SLR Project No.: 184398

RE: Bridge Farm RMA 243124 – Letter of Objection

Date: 22 November 2022
Application: 223455

PROJECT: Land north of the A4, New Bath Road, Twyford				CLIENT: David Wilson Homes	
DRAWING TITLE: PROPOSED MINOR SECONDARY SITE ACCESS NEW BATH ROAD GENERAL ARRANGEMENT AND VISIBILITY SPLAYS				PART OF vectos. SLR	
DRAWN: SCJ	CHECKED: jb	DATE: 01/03/23	SCALES: AS SHOWN @ A1	DRAWING NUMBER: 184398-PD14	REVISION: C

VISIBILITY TO THE WEST - SCALE 1:500

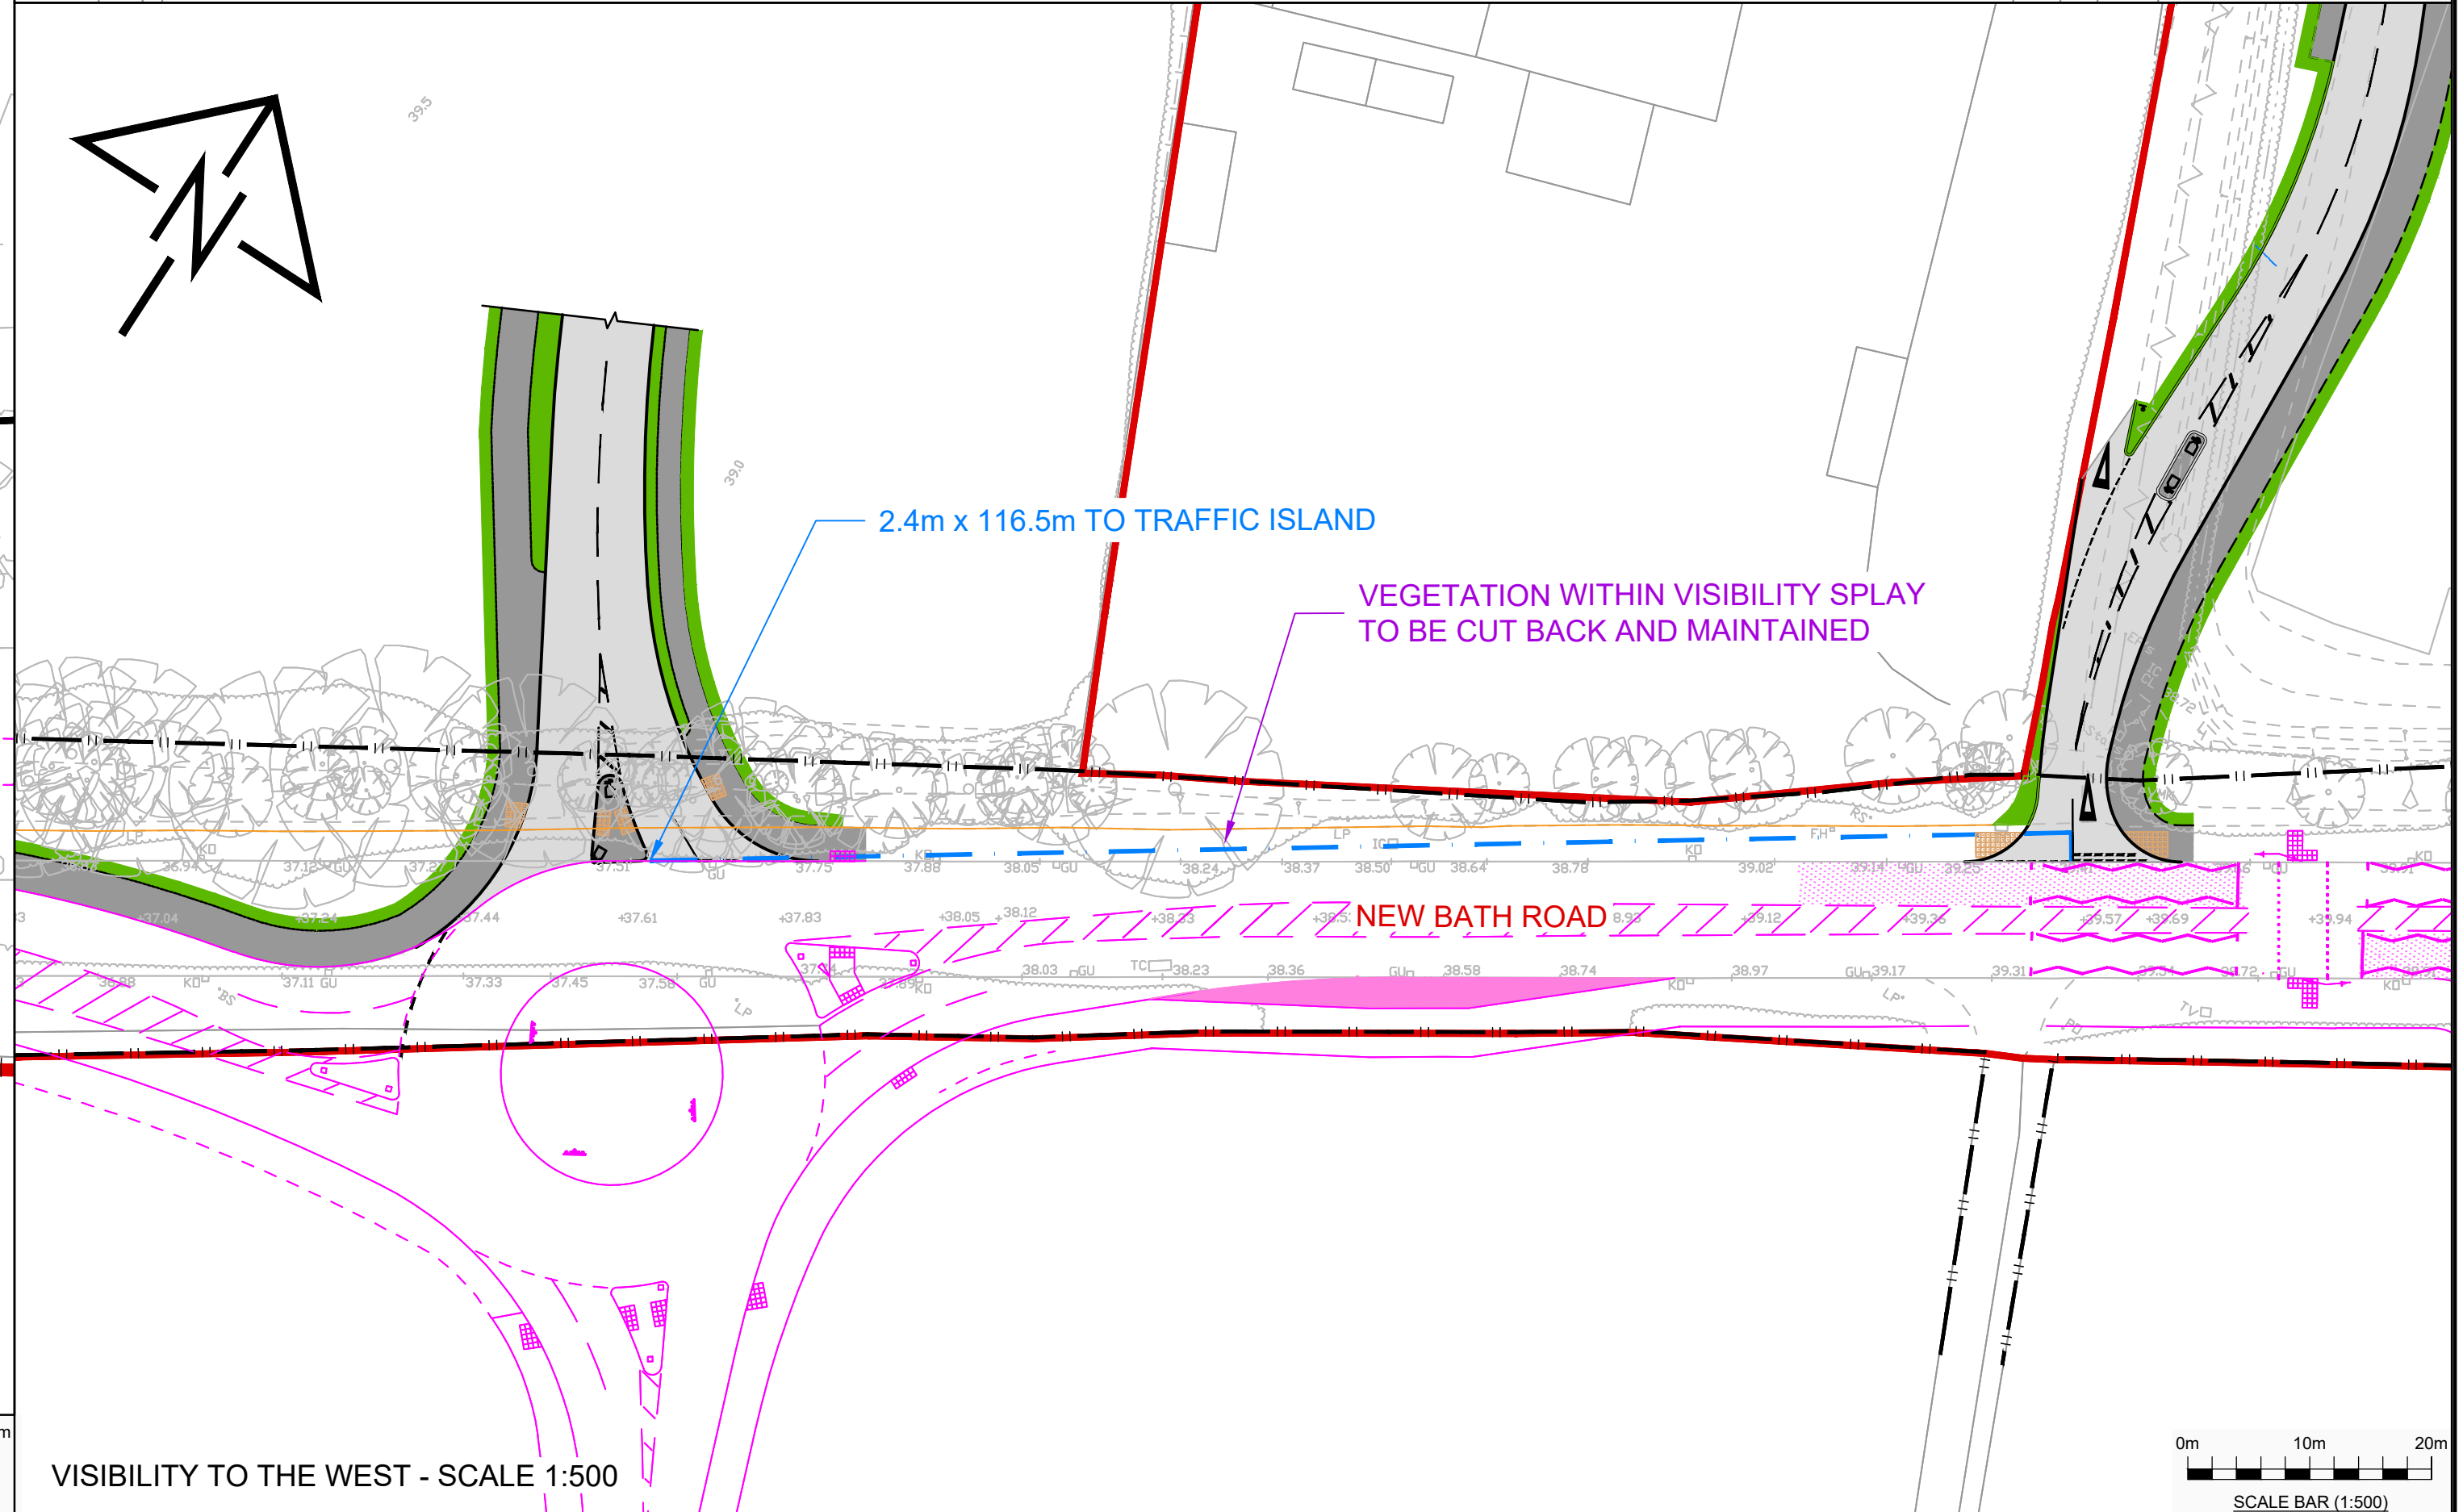
The access that is referred to in the extract from the final highway response refers to the proposal to upgrade an existing access to the site to provide access to at least 50 dwellings. A copy of this drawing is also enclosed.

You will note when reviewing this drawing that the access was designed having regard to the location of a Toucan crossing approved pursuant to the Bridge Farm outline consent (Ref: 212720). This crossing is shown in magenta lines and is located some 19 metres to the east of the existing access to Loddon Park Farm, which was shown as being upgraded on enclosed Drawing 184398-PD14 Rev C.
